# ADDENDUM NO. 3

**August 13, 2026**

Perry Township Schools:
Southport High School Addition & Renovation Phase 2 (Classroom Addition and Athletic Renovations)
971 E. Banta Road
Indianapolis, IN 46227

1. Drawing Sheet Number: C-4.4
   Drawing Sheet Title: DEMOLITION PLAN

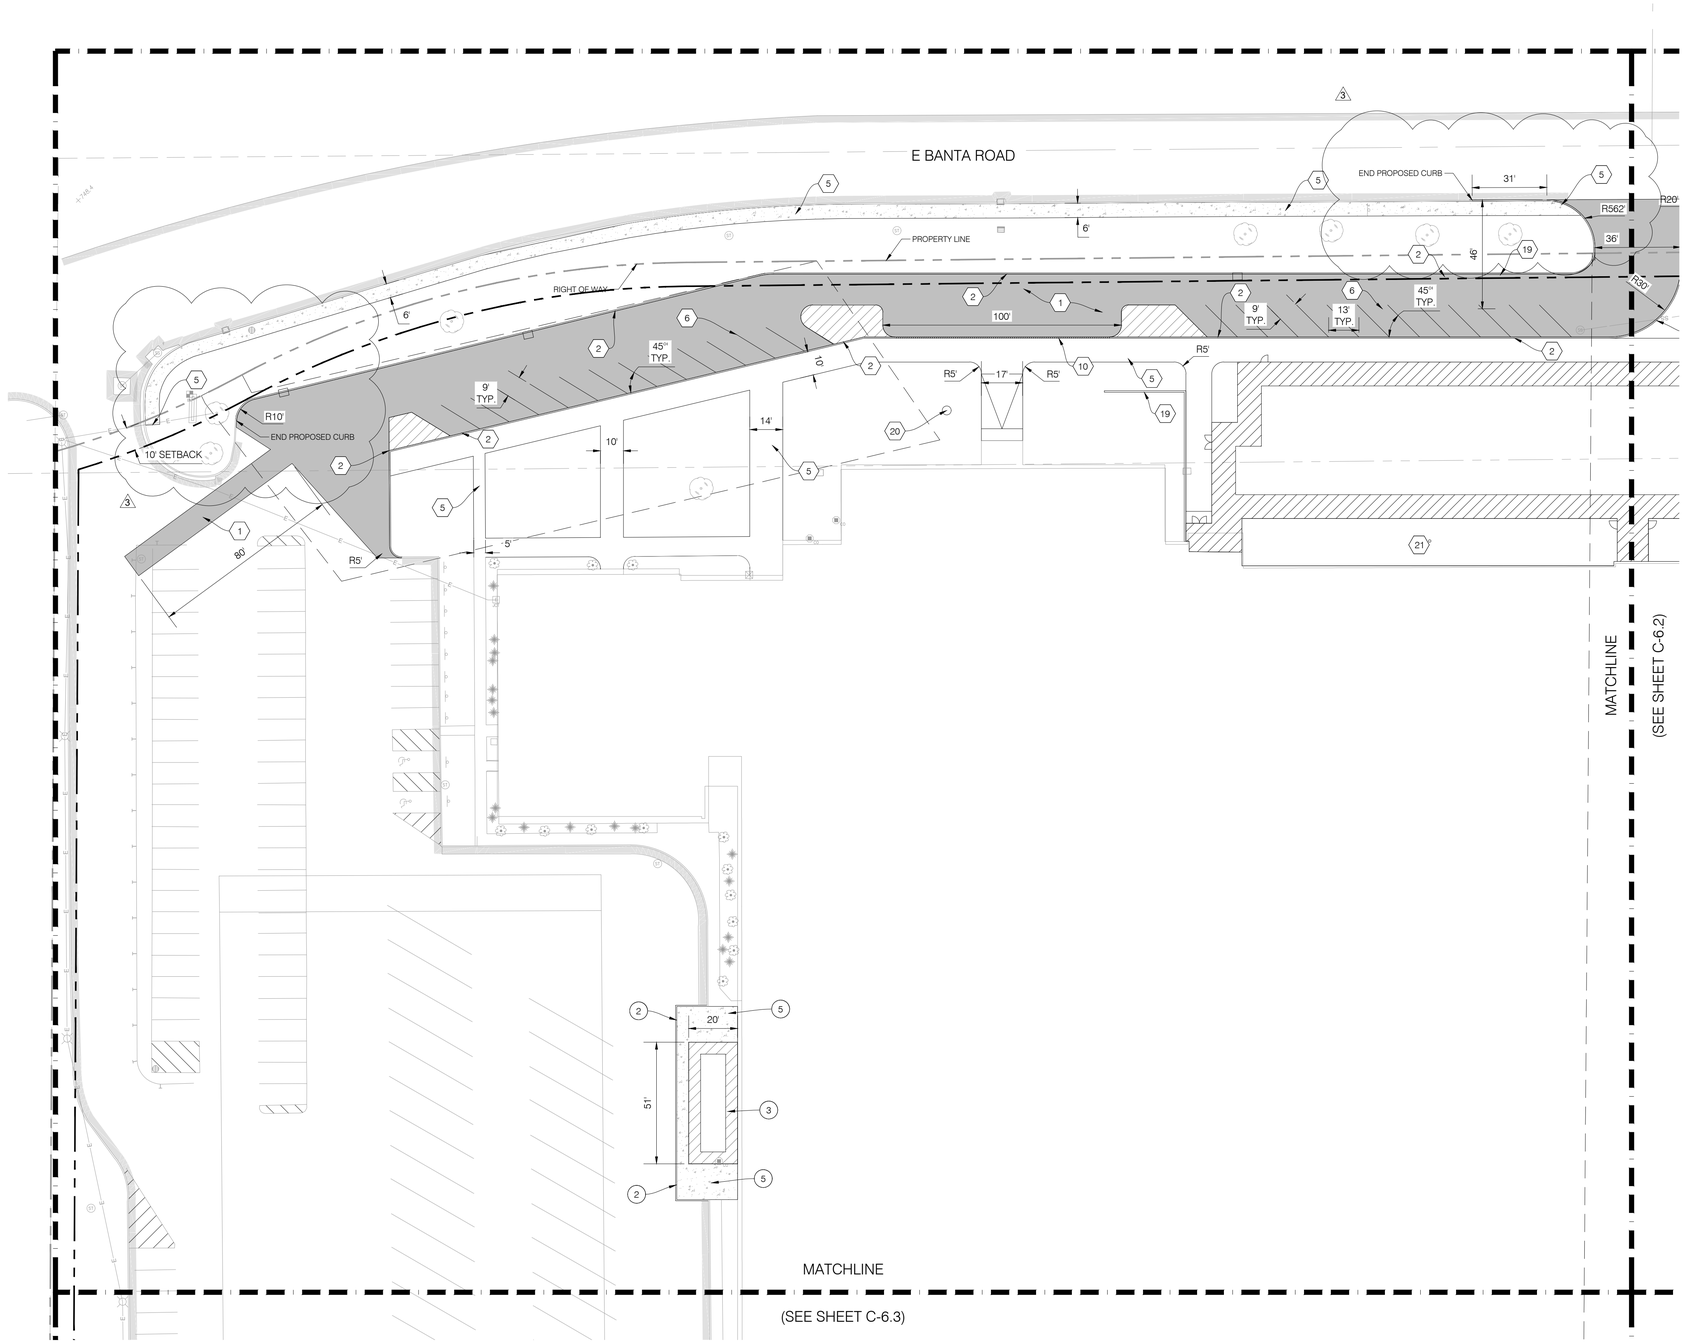
Change: Added Sheet
   - Added the sheet to show the demolition notes for the extents of the sidewalk along Shelby Street.

C-6.1

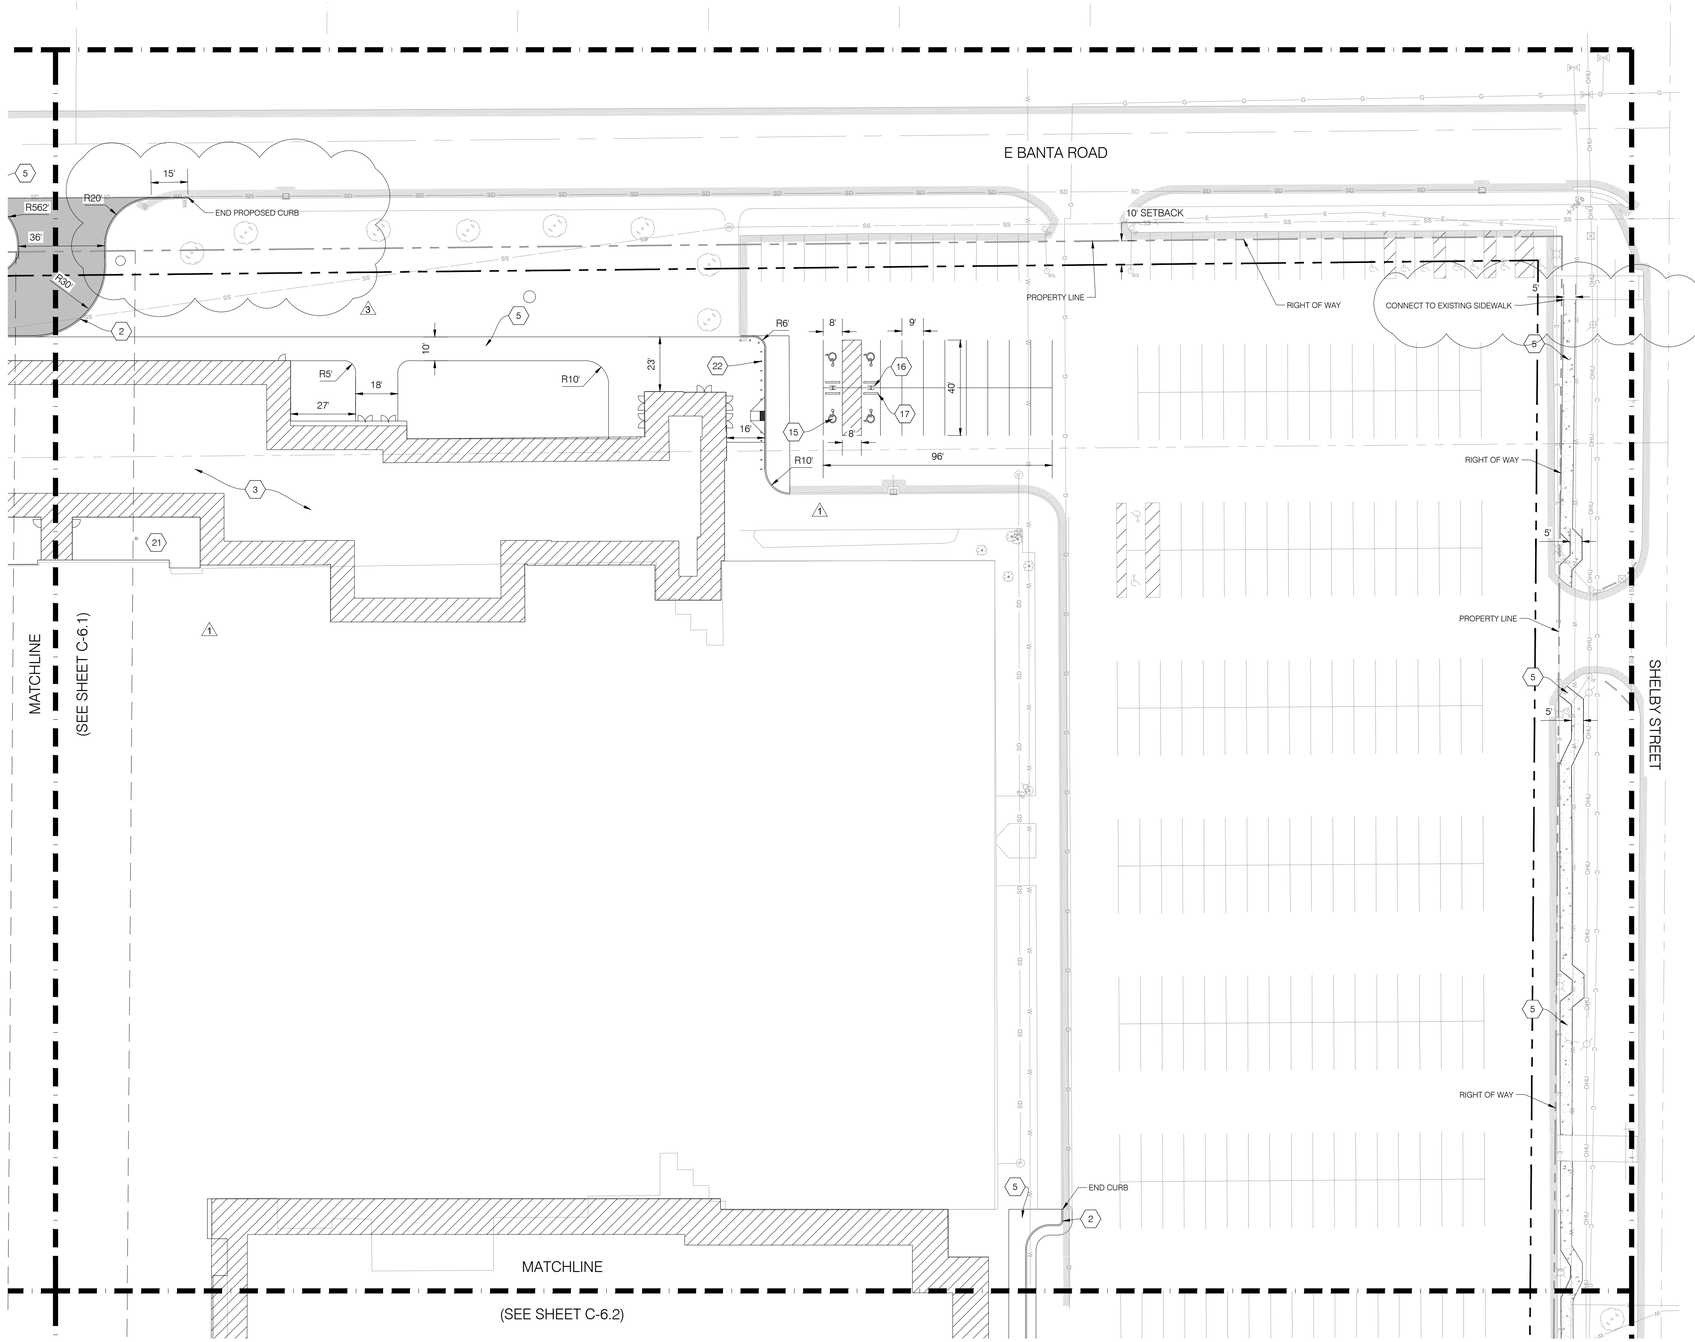
Change: Updated Site Plan
   - Added notes and dimensions to show the extents of the concrete curb

C-6.2

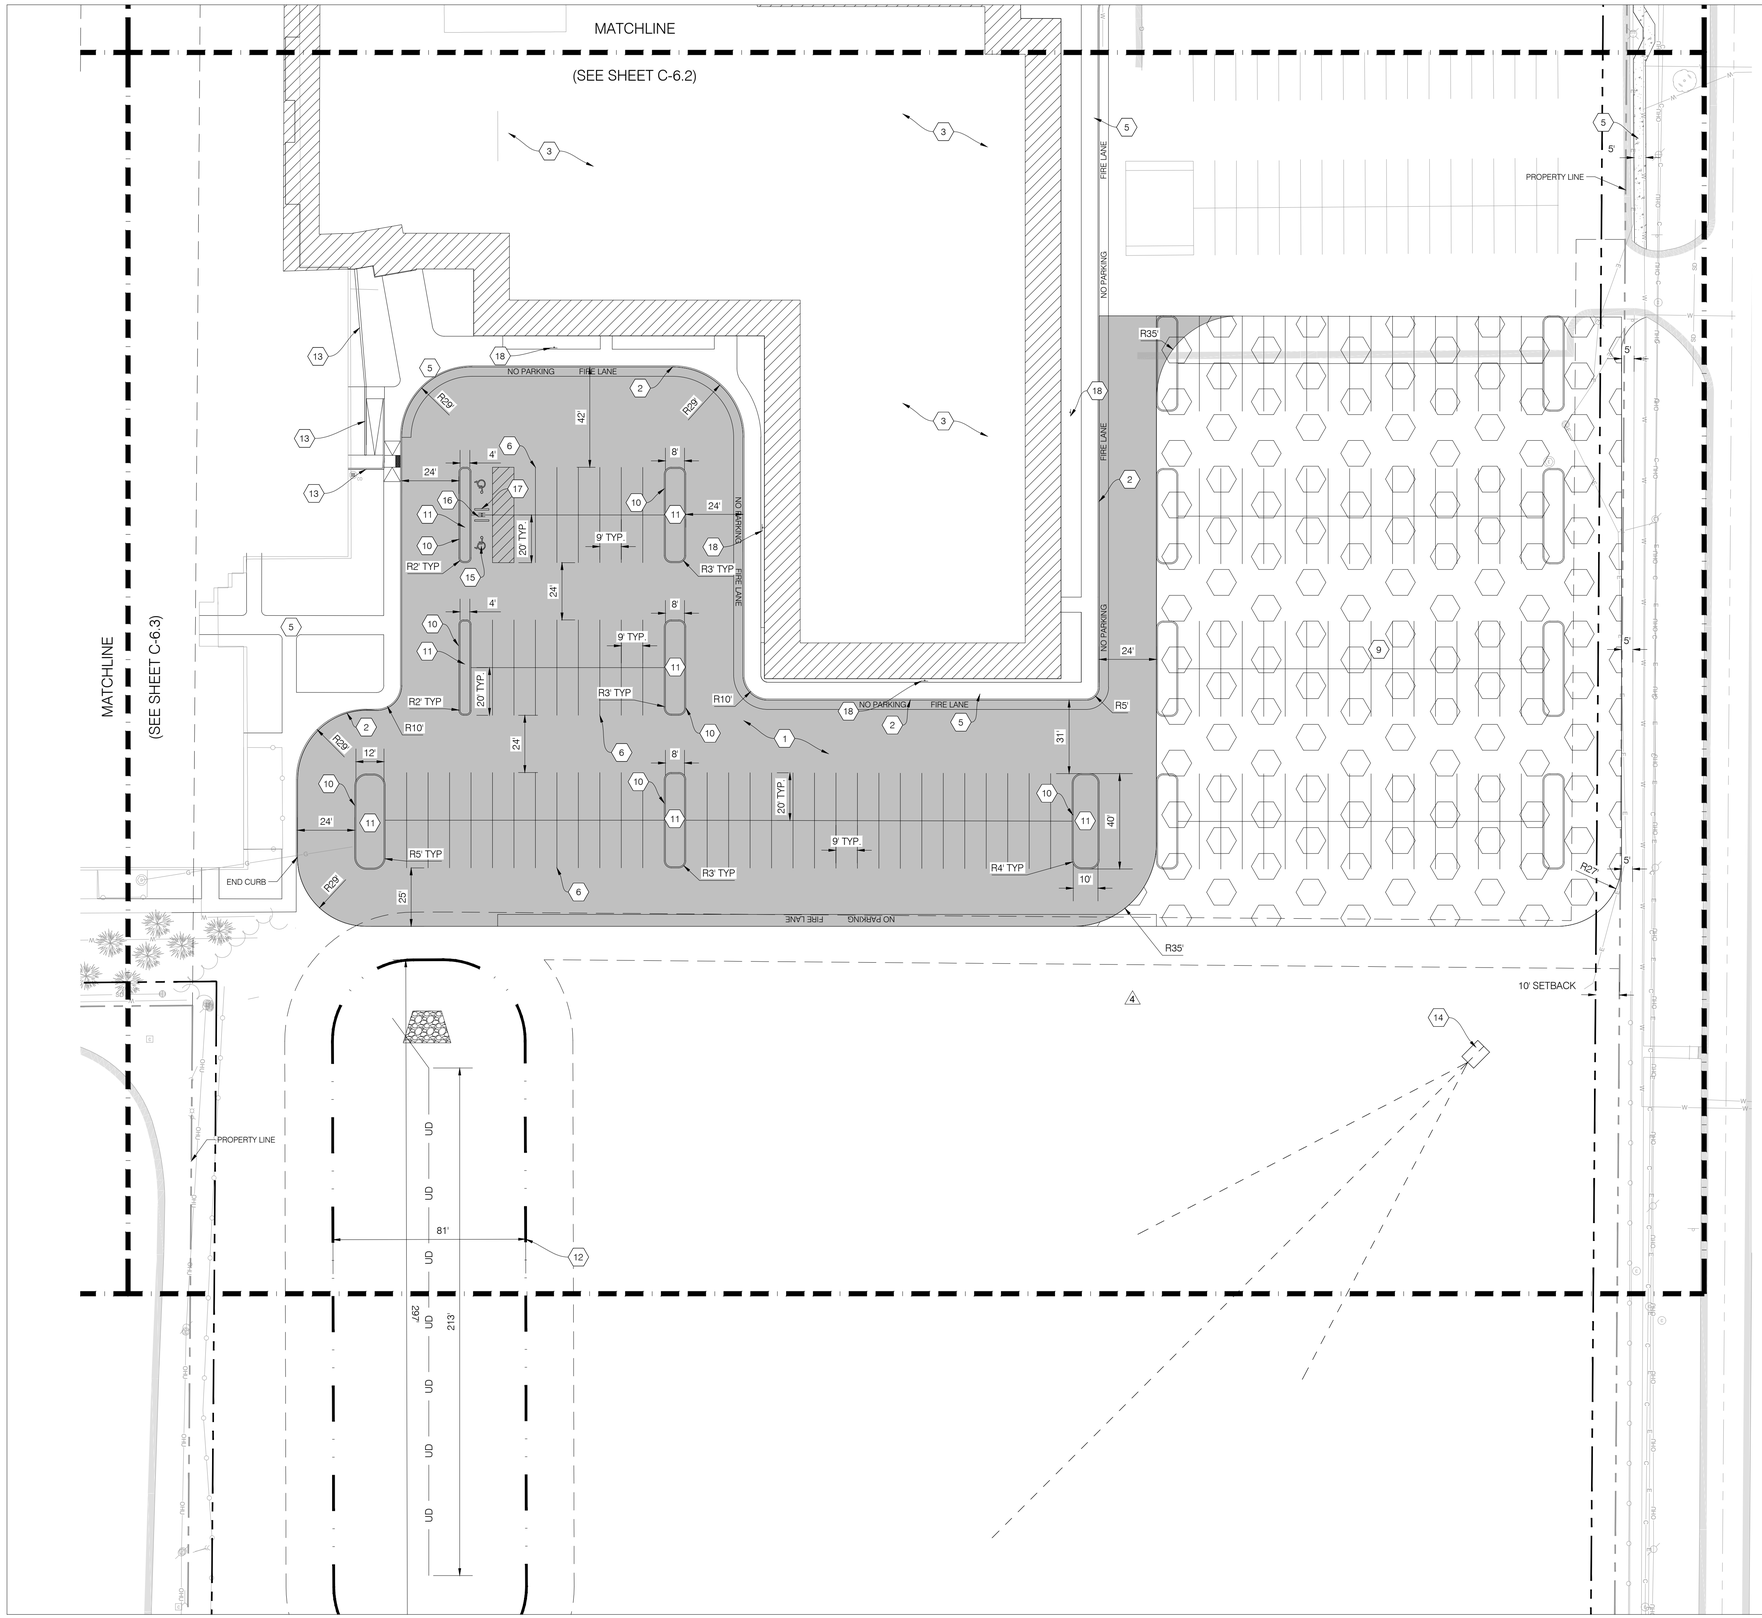
Change: Updated Site Plan
   - Added a note to show the extent of concrete curb
   - Added a note to show sidewalk along Shelby Street tying into existing walk.
